SAFETY EVALUATION BY

THE OFFICE OF NUCLEAR REACTOR REGULATION

RELATED TO NRC GENERIC LETTER 2004-02,

SUMP PERFORMANCE EVALUATION METHODOLOGY"

Figure 3-1. Comparison of GR Isobar Map (Blue) with Isobars from Independently Evaluated ANSI Jet Model (Red)

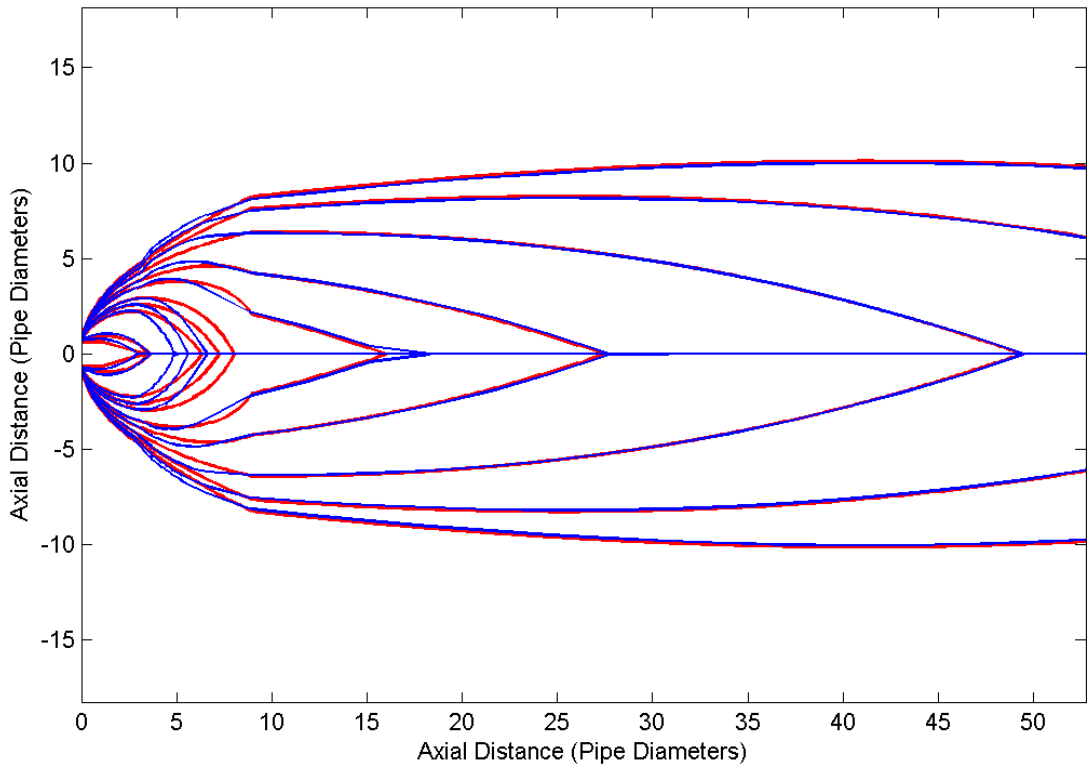
In order to confirm that the ANSI jet model was implemented properly, the model was independently programmed and the results compared with the isobar map tabulated in Table D-1 of the GR. This comparison is shown in Figure 3-1 in which the blue contour lines represent the GR evaluation of a break at 2250 psia and 540°F and the red contour lines represent a reference cold-leg break at 2250 psia and 530°F. Appendix I to this SE provides further explanation of the independent calculation and additional guidance on interpreting the results of the ANSI jet model.

Good agreement is seen between the calculations for downrange behavior (Zone 3), but discrepancies exist in Zones 1 and 2. It appears that contour termination points on the centerline are not accurate and that the quadratic behavior of the Zone 2 isobar equations is not implemented correctly. These differences will have a negligible effect on volume integrals for jet pressures less than 20 psig, but may become more of a concern for higher pressures near the break. To quantify the magnitude of the difference, Table 3-1 below presents a comparison of ZOI radii computed from both methods. In particular, the GR approach may not have preserved the system stagnation pressure throughout the volume of the liquid core region, as specified by the standard. However, the GR recommended values essentially bound both sets of calculated values.
